YEAR 6 (2020) MONITORING REPORT
ABBEY LAMM
STREAM AND WETLAND MITIGATION SITE
ALAMANCE COUNTY, NORTH CAROLINA
FULL DELIVERY CONTRACT No. 5790
DMS PROJECT No. 96311
NCDWR PROJECT No. 20140336
USACE ACTION ID No. SAW-2014-01710

Response to Monitoring Year 6 (2020) DMS Comments

Abbey Lamm Stream and Wetland Mitigation Site (DMS #96311)
Cape Fear River Basin 03030002, Alamance County
Contract No. 005790

Lamm Surface Gauge UT-1 Upstream Year 6 (2020 Data)

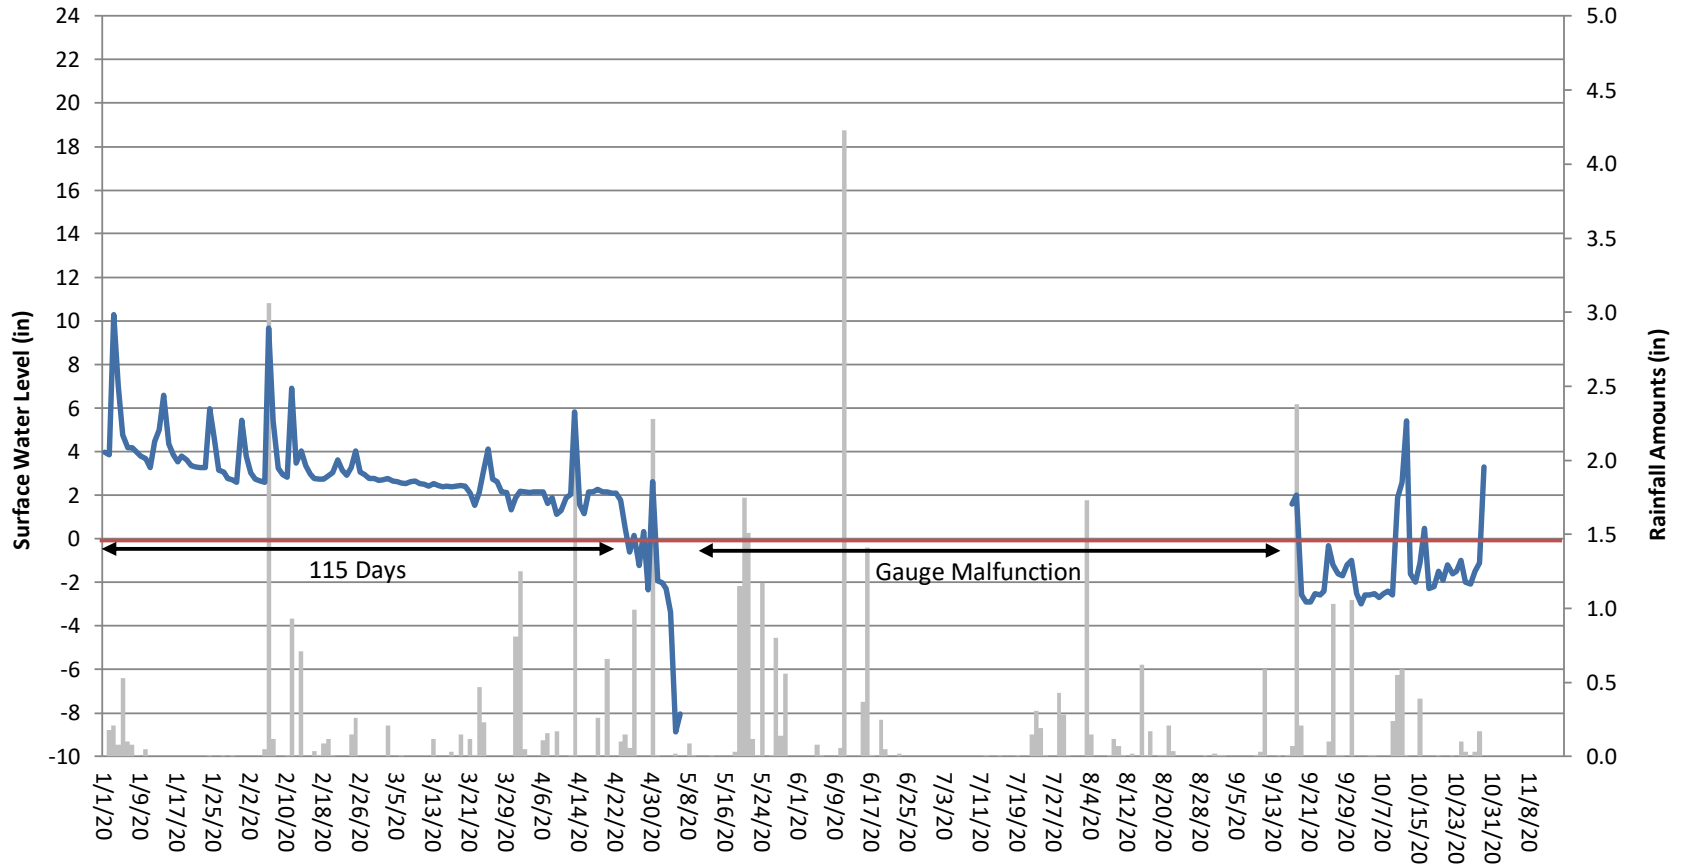
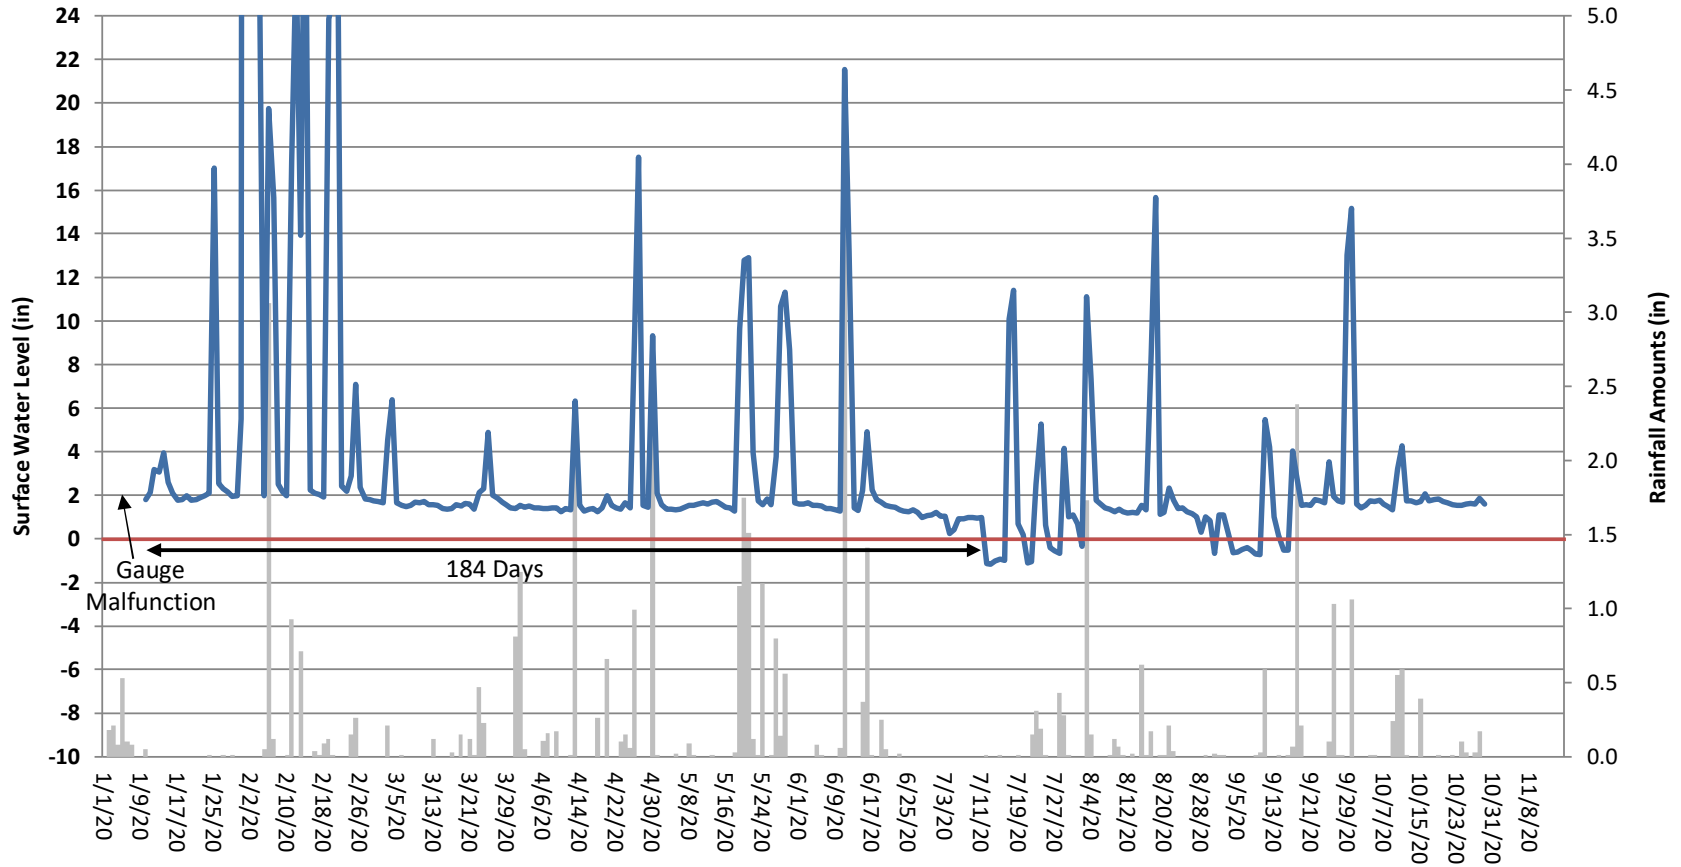
2. Appendix D
 - a. Please include the surface water gauge figures for UT-1.
Surface water gauge figures have been included with this submittal.
 - b. Please include the groundwater gauge figures after Table 11.
Groundwater gauge figures have been included with this submittal.

Lamm Groundwater Gauge 6 Year 6 (2020 Data)

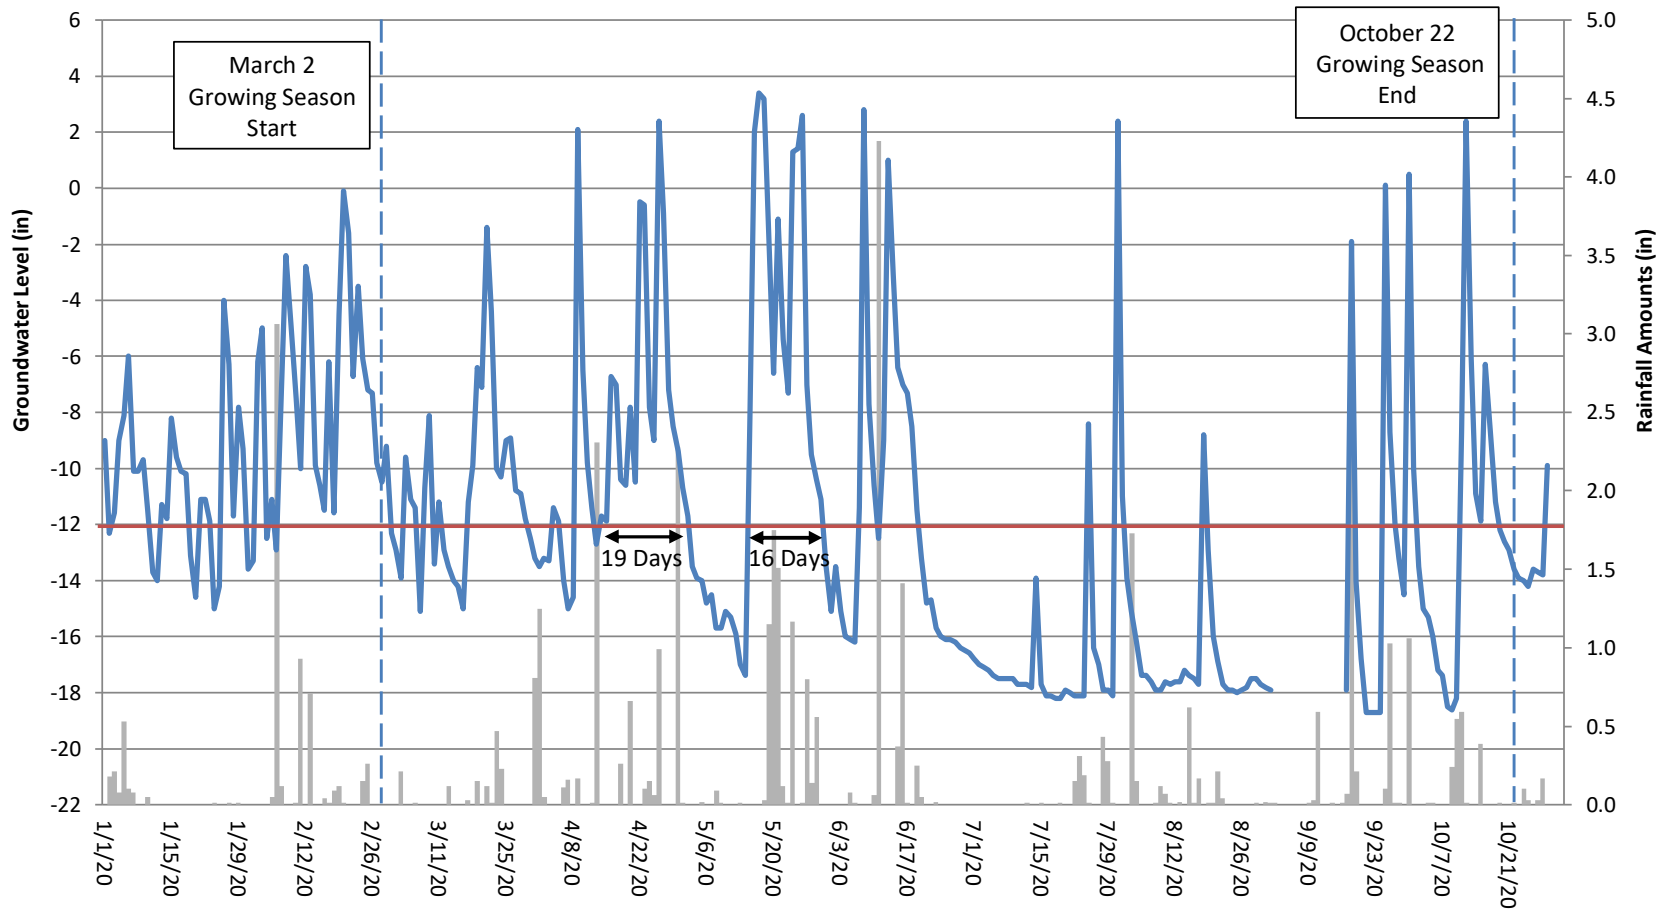
3. Wetland credit around gauges 6 and 6B are at-risk due to each gauge only meeting success once, both in 2018. To date 85% of the total project wetland credits have been released. DMS will hold payment for the wetland component until credit release. Please discuss size of area at risk, factors contributing to falling short of success criteria, and potential, if any, for this wetland area's credit to be realized.
Understood. To evaluate the wetland restoration credit around gauge 6 and 6B, Raymond Holz and Alex Baldwin (PWS 2221) of Restoration Systems (RS) visited the Site on 12/8/2020 to review the subject area. Site work indicates 0.080 acres around gauge 6 and 6B is not meeting the Site's 10% hydroperiod period success metric.

To further provide an understanding of the Site's wetland mitigation assets, RS mapped the wetland areas within the old pond bed along the "Mainstem" tributary at the western extent of the Site. RS installed three groundwater monitoring gauges in 2016 (Yr. 2 of monitoring) within this area, and has collected groundwater data for the last five years. In conjunction with 12-2020 field review, the groundwater data indicates successful wetland reestablishment of 0.862 acres.

Data collected during RS' field investigation is provided in a newly added appendix and supplied in shapefile format within the digital deliverable dataset. RS' position is that although the 0.080 acres around gauge 6 and 6B is not meeting the hydroperiod metric, the Site is providing more than the 1.0 WMU detailed in the Restoration Plan. RS is not asking for additional credit be added to the ledger but that the agreed-upon 1 WMU remains and is not subject to a downward adjustment by the IRT. RS expects to discuss this with the IRT during the 2021 Credit Release Meeting.
